APPLICATION FOR THE PROPOSED ABLE MARINE ENERGY PARK ON THE SOUTH BANK OF THE RIVER HUMBER AT IMMINGHAM, NORTH LINCOLNSHIRE

PLANNING INSPECTORATE REFERENCE NUMBER: TR030001

1.1 The East Yorkshire and Derwent Area of the Ramblers **object** to the application for the **"Alteration to the local network at Cherry Cobb Sands"** as proposed by Able UK.

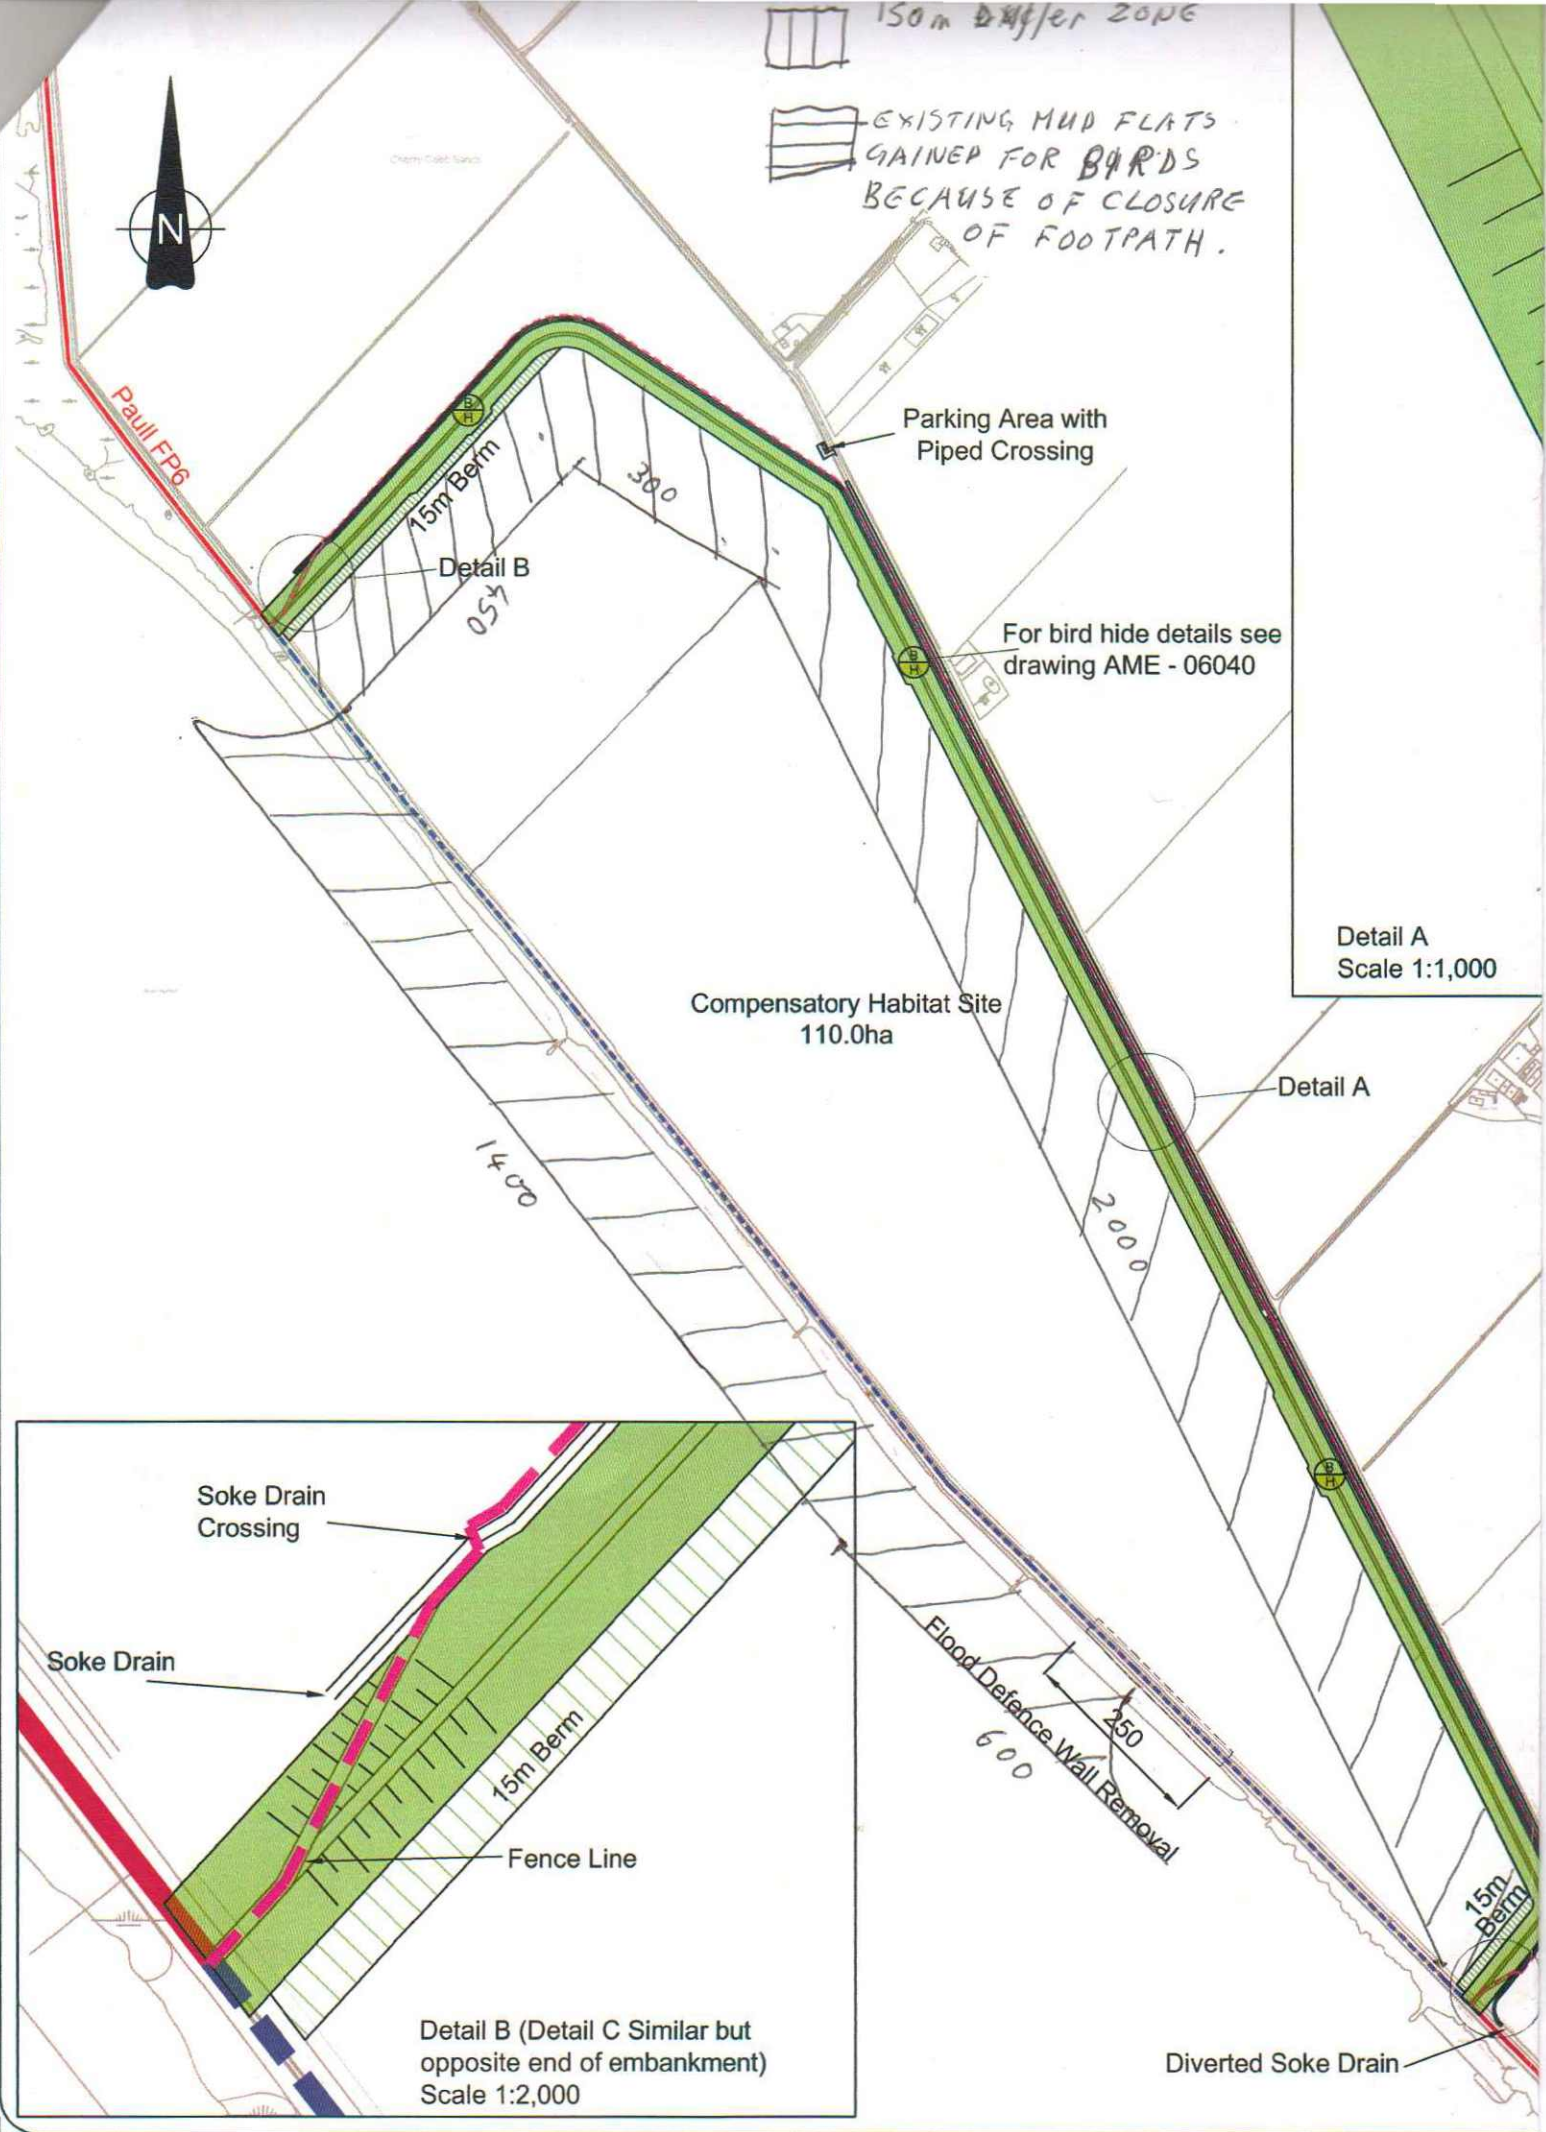
2.1) On your map I have drawn a 150m buffer strip between the top of the bank and the river. This leaves 67 ha. Outside the buffer zone, which is more than you are taking on the south bank.

2.2) The plan does not show which areas are to be "mudbanks" and which are to be "saltmarsh"

2.3) The closure of the existing footpath (Paull 6) will give an additional 30 ha to the site from which the public and dogs will not be disturbing birds.

2.4) A large section of the 55 ha site south of the river, is at present unavailable to birds as a) it is below low tide, b) there is a footpath along the river bank which needs a 150m strip removing from the measurements.

2.5) Therefore the Ramblers propose that the footpath should be diverted around the top of the flood Defence wall.

2.6) The above calculations are based on the footpath south of the 250m breach in the flood Defence wall being kept open.

2.7) As there are no measurements on the plan, I have scaled them to the best of my ability.

150m Buffer Zone
EXISTING MUD FLATS
GAINED FOR BIRDS
BECAUSE OF CLOSURE
OF FOOTPATH.
